SUBJECT: **Customer Satisfaction Program 25N05**
Certain 2021-2023 Model Year F-150 HEV Vehicles
Replacement of Exhaust Gas Heat Recovery Coolant Spigot, If Required

REF: **Customer Satisfaction Program 24N04 – Supplement #1**
Certain 2021-2023 Model Year F-150 HEV Vehicles and 2022-2023 Model Year
Maverick HEV Vehicles
Replacement of Exhaust Gas Heat Recovery System if Failed
December 2, 2024

Customer Satisfaction Program 25N05

FIGURE 1

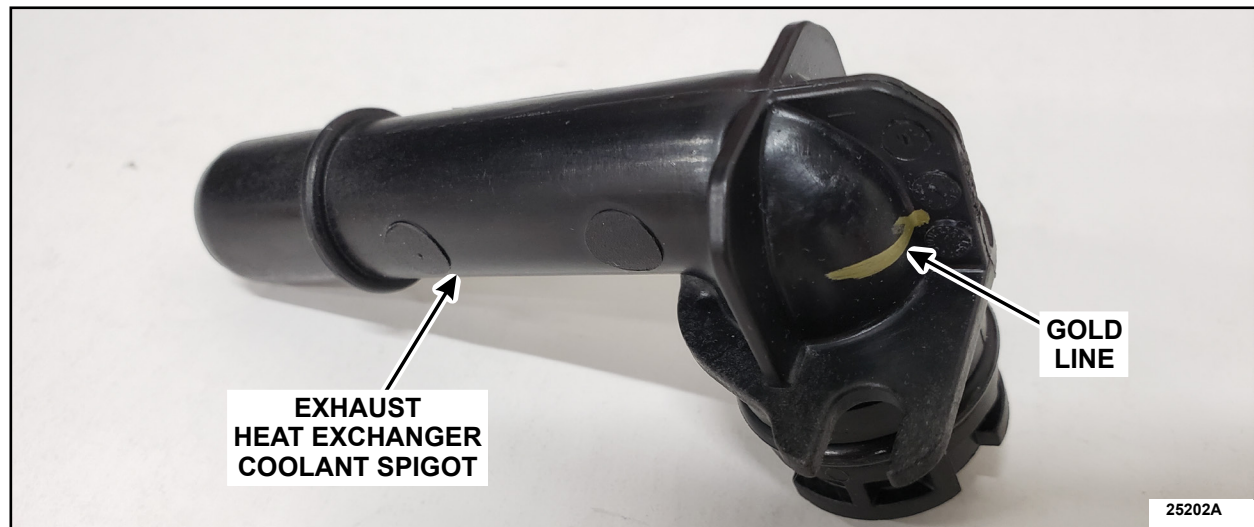
1. Remove both of the exhaust heat exchanger coolant spigots. Follow Workshop Manual (WSM) procedures in Section 309-00D.
2. Visually inspect the *new* exhaust heat exchanger coolant spigots for a gold line marking. The gold line marking indicates the correct part(s) for installation. If the spigots do not have the gold line marking, do not use these parts and order new spigots. See Figure 1.

3. Install both of the *new* exhaust heat exchanger coolant spigots that have a gold line. Follow Workshop Manual (WSM) procedures in Section 309-00D.
